From: Mervyn Frazer [REDACTED]
Sent: Sunday 27 March 2022 19:07
To: Development Plan
Subject: RPS 889 Kilmurry Lime Kiln
Attachments: IMG_3575.JPG; IMG_3576.JPG

We are writing to you regarding the development/restoration of Kilmurry Lime Kiln, which is located on our property in Kilmurry, Sixmilebridge, Co. Clare.

Kilmurry Lime Kiln

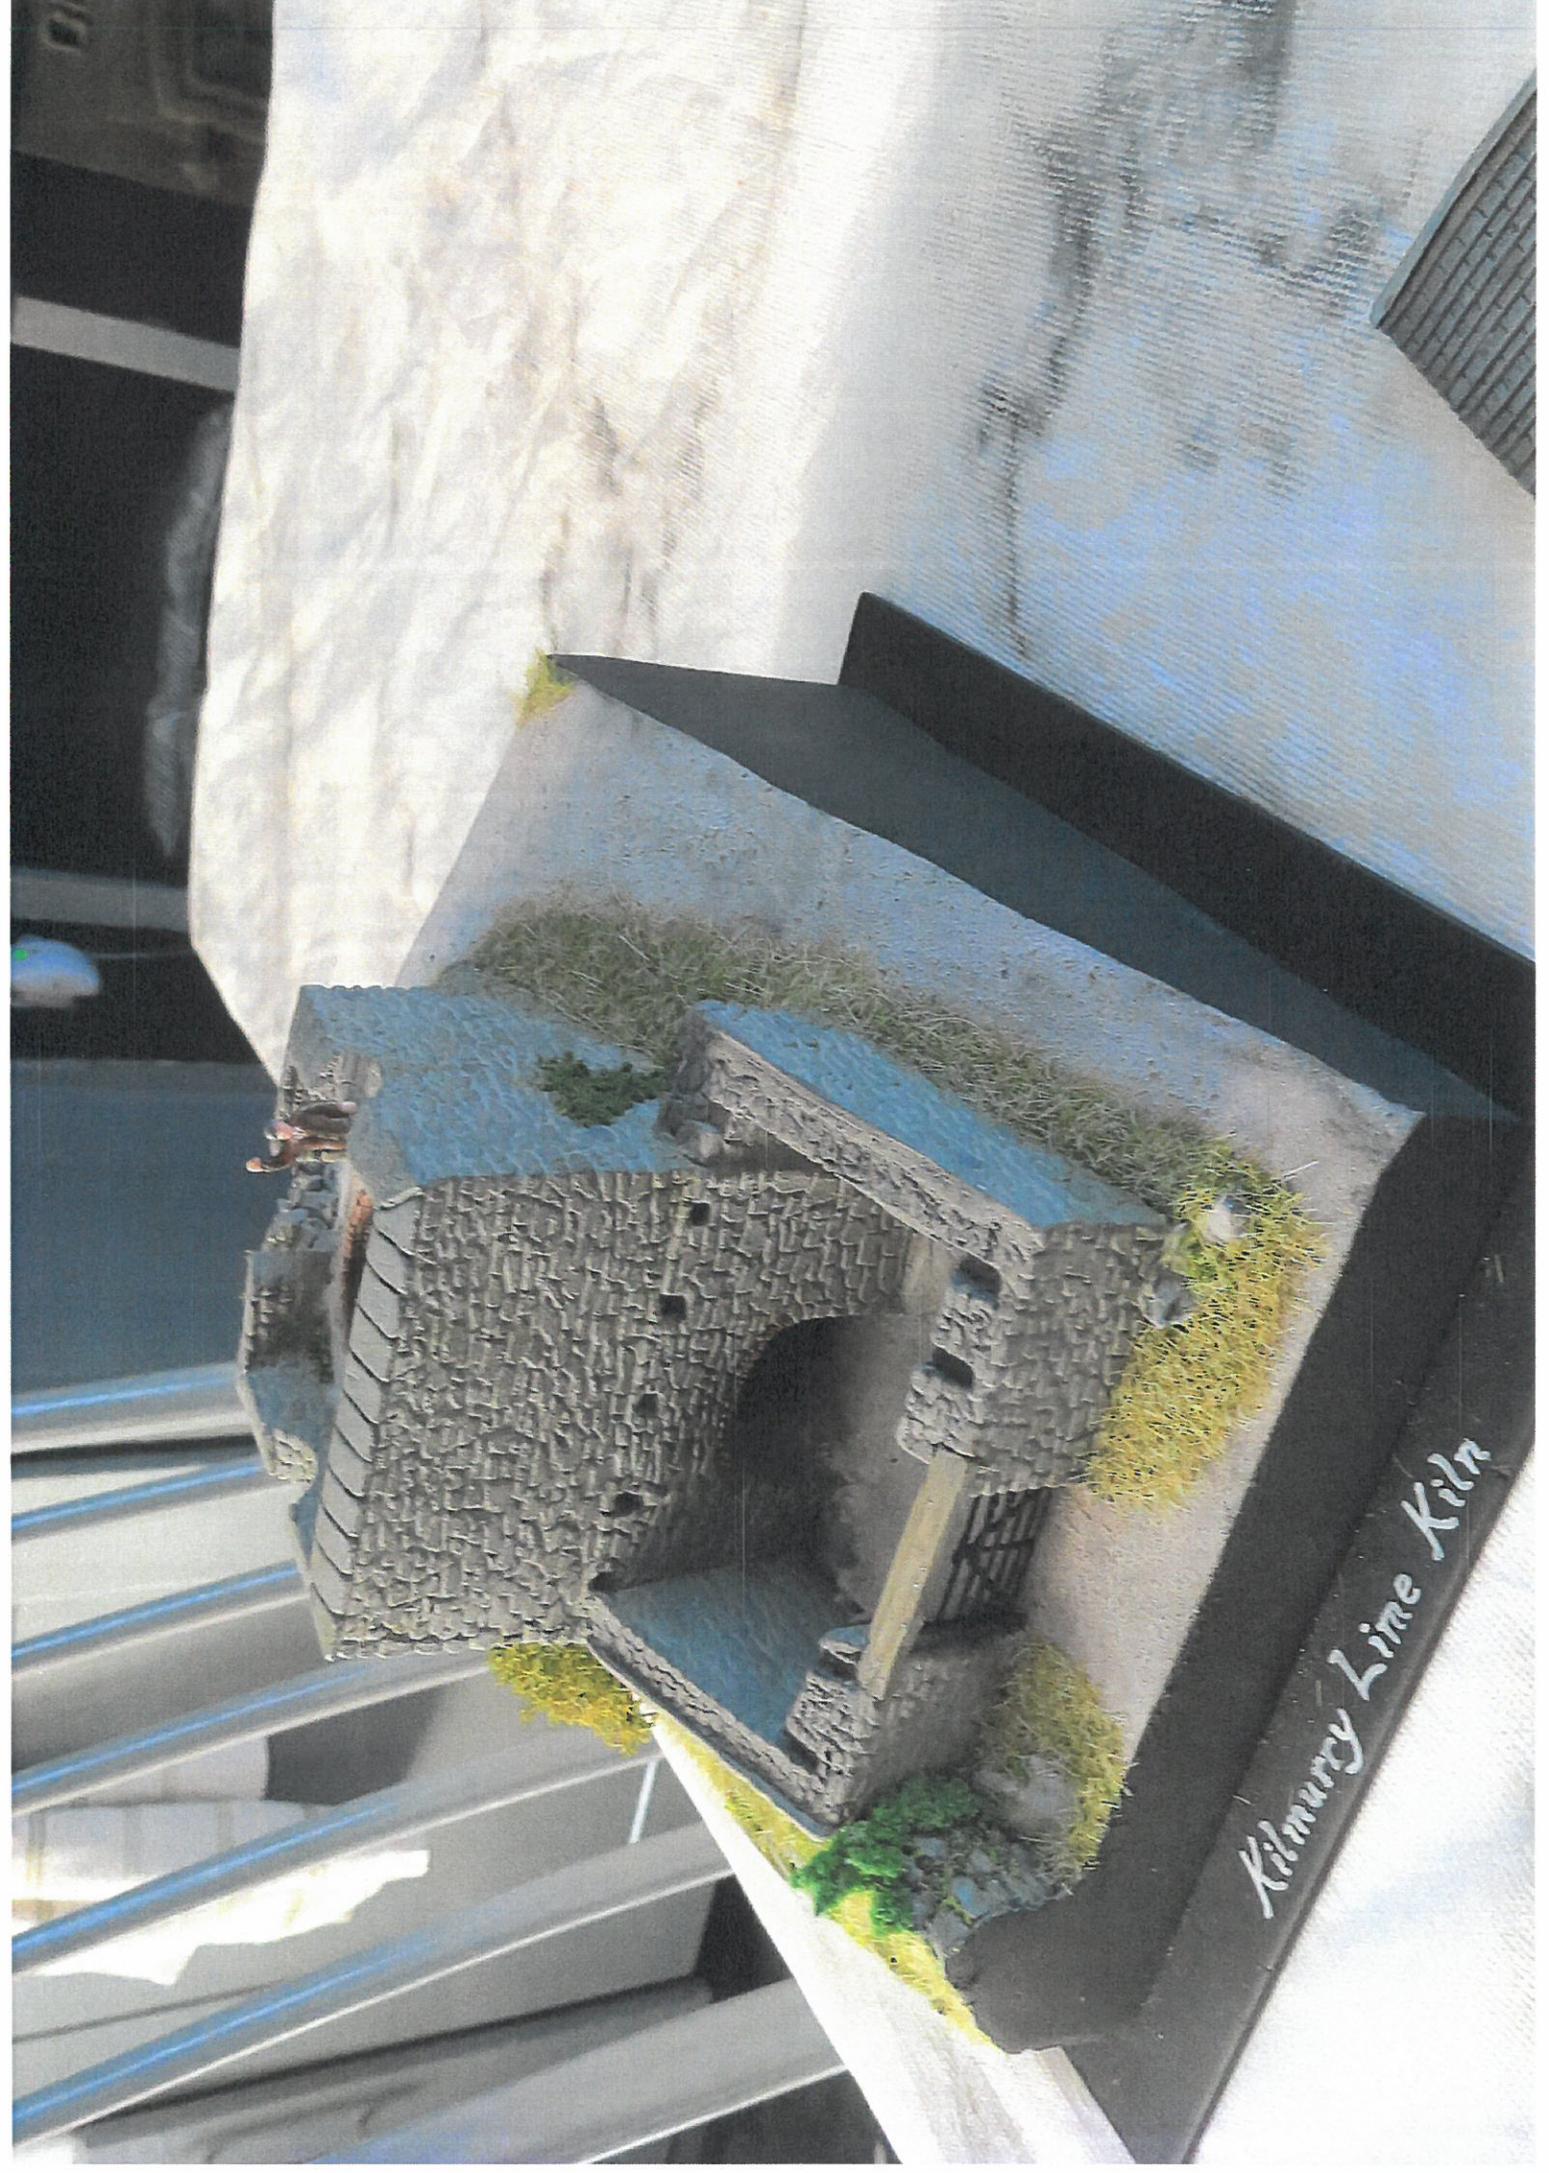
The repaired walls to be all pointed in the original style of the time. The two front walls to be built on the existing original foundations that are still there to be seen. The internal pot to be pointed using brown mortar pointing that was also originally used, and the same on the outside front, over and around the draw hole.

The top of the wall to be finished in stone and not capped with concrete as this was not the original material used.

A stone slated roof over the two front (entry) original wall with a gate.

Restoration carried out so far has not been to the original way, or look, and needs to be corrected before further restoration is carried out.
